Village of Arlington Heights
Plan Commission
Board Room
Arlington Heights Village Hall
33 S. Arlington Heights Road
Arlington Heights, IL 60005
December 14, 2016
7:30 PM

- A. Medical Office -1519 S. Arlington Heights Rd. - PC#16-022
Rezoning, Subdivision, PUD, Amendment to PUD
- B. Arlington Heights Animal Hospital - 412 W. Algonquin Rd. -
PC#16-023
Land Use Variation for a Kennel

RE: LEXINGTON HERITAGE TOWNHOMES - PC# 16-021

SHEET
3
WWW.AHL01

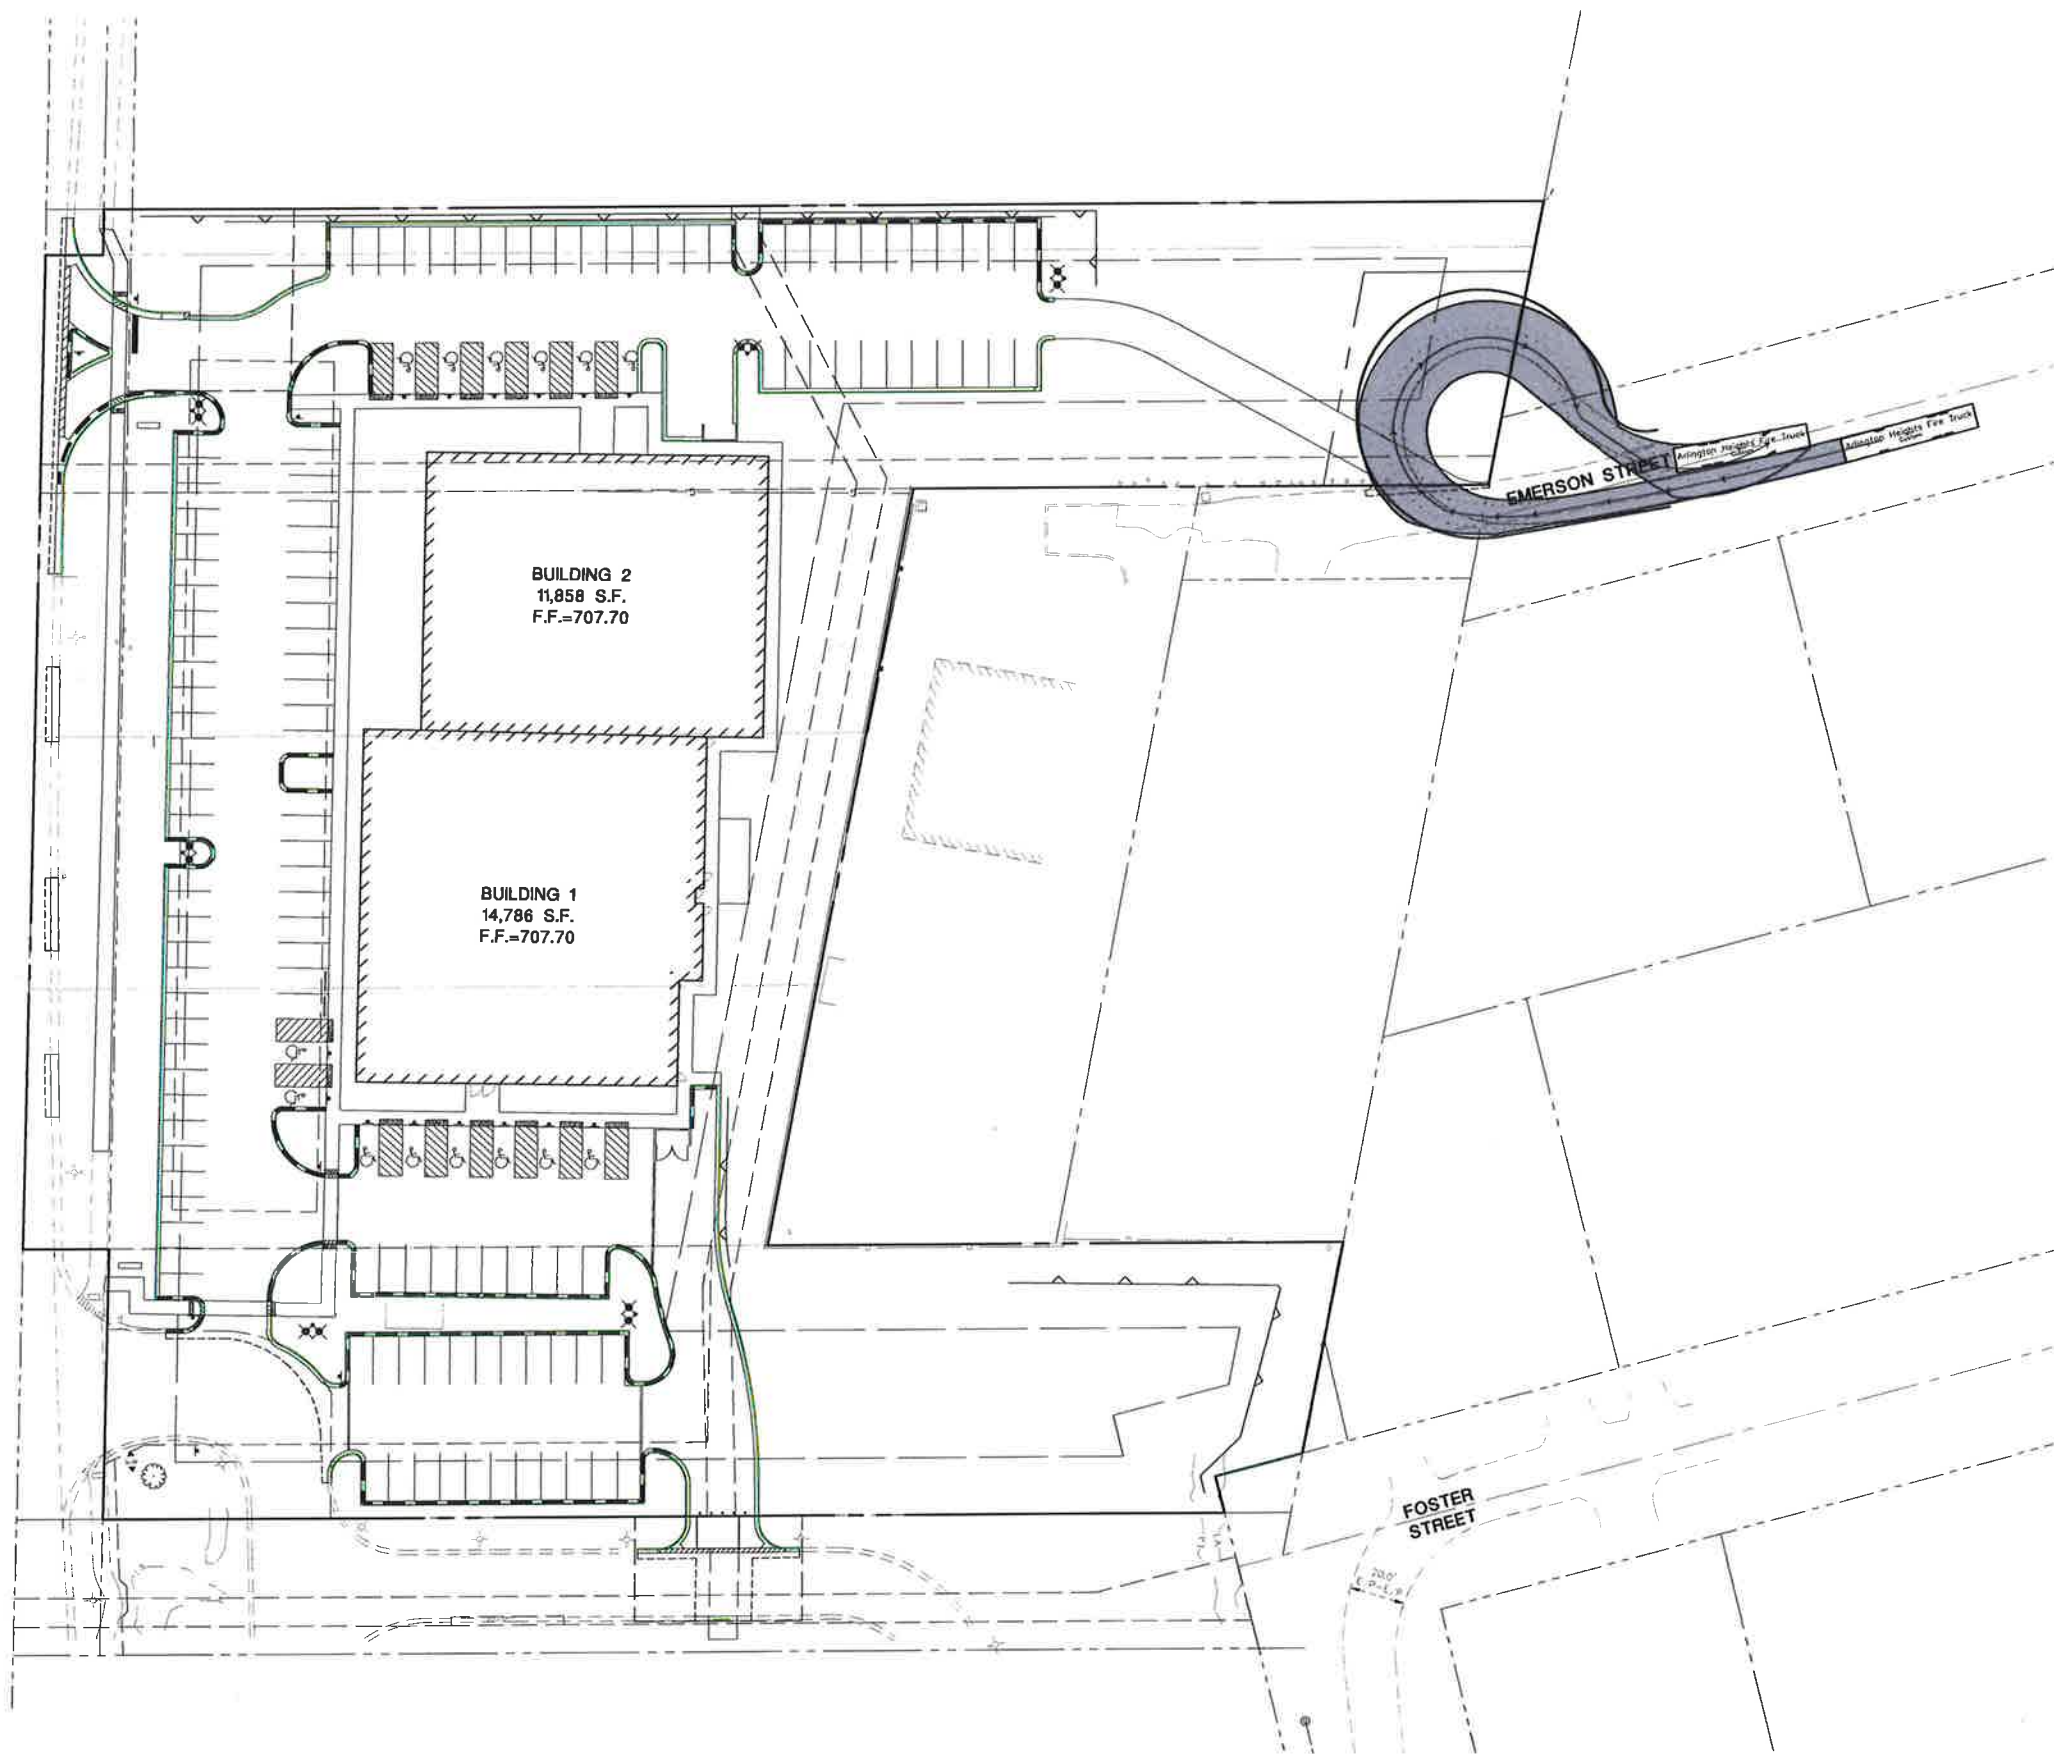
20. We received exhibit sheets 2-4, but not sheet 1 showing the turning path of the Fire Department's responding vehicle. Sheets 2 and 3 have the truck driving over the pork chop median at the north driveway.

We received exhibit sheets 2-4, but not sheet 1 showing the turning path of the Fire Department's responding vehicle. Sheets 2 and 3 have the truck driving over the pork chop median at the north driveway.

Sheet 1 of the Fire Truck Turn Exhibits has been included for review. The pork chop on the right-in/right-out is called out to be mountable curb.
